[Docket No. 2001-SW-40-AD; Amendment 39-13022; AD 2002-13-05 R1]

Airworthiness Directives; MD Helicopters, Inc. Model 369D, 369E, 369F, and 369FF Helicopters

ACTION: Final rule.

Figure 1 - Inspection Location

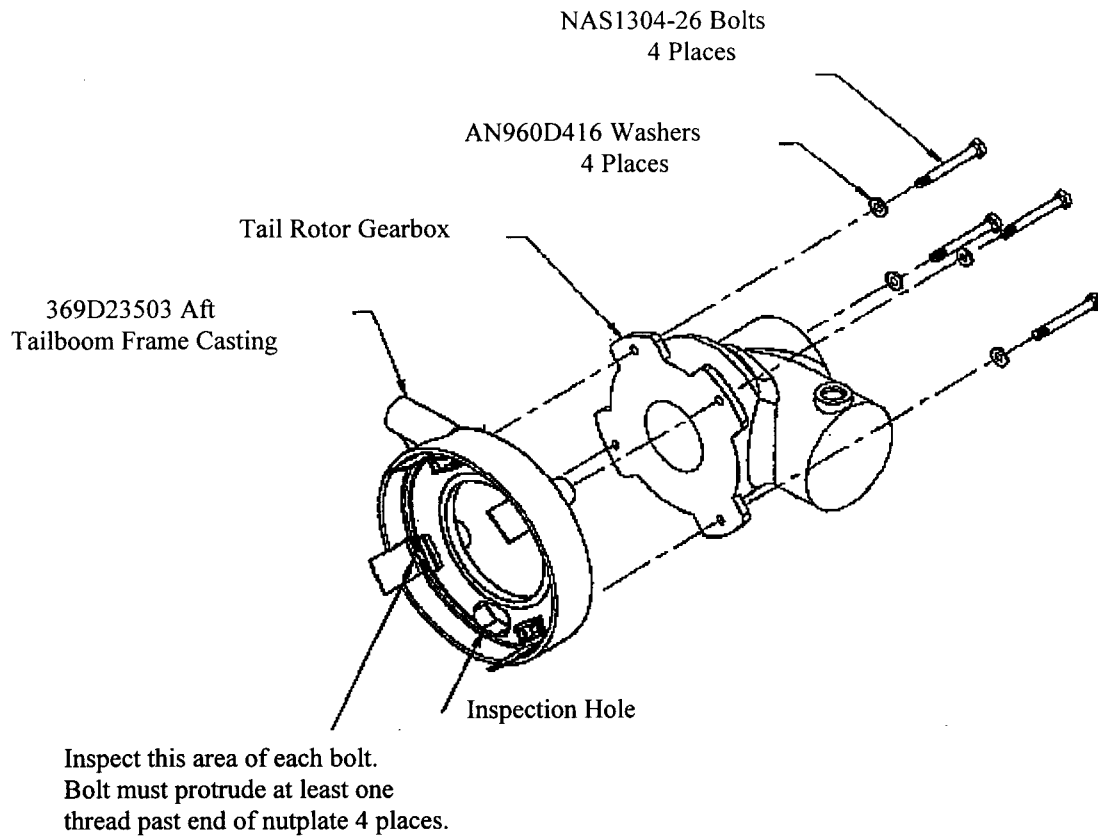
concern was valid. We are now reducing the applicability of AD 2002-13-05 to include only certain tailboom S/N's and parts that are modified in accordance with either STC SH5055NM or SH4801NM. We are also correcting the P/N for the washer to P/N AN960D416 in Figure 1 of this AD and clarifying that a slippage mark needs to be reapplied to each bolt regardless of the outcome of the required torque test.

(2) Remove the tailboom control rod and determine the number of bolt threads protruding from each nutplate on the internal surface of the aft tailboom frame casting, P/N 369D23503, as shown in Figure 1 of this AD. At least one thread must protrude. If more than four threads protrude, add an additional washer, P/N AN960D416, under the bolt head. Torque the bolt to 100–110 in-lbs, and reapply a slippage mark. *See Figure 1:*
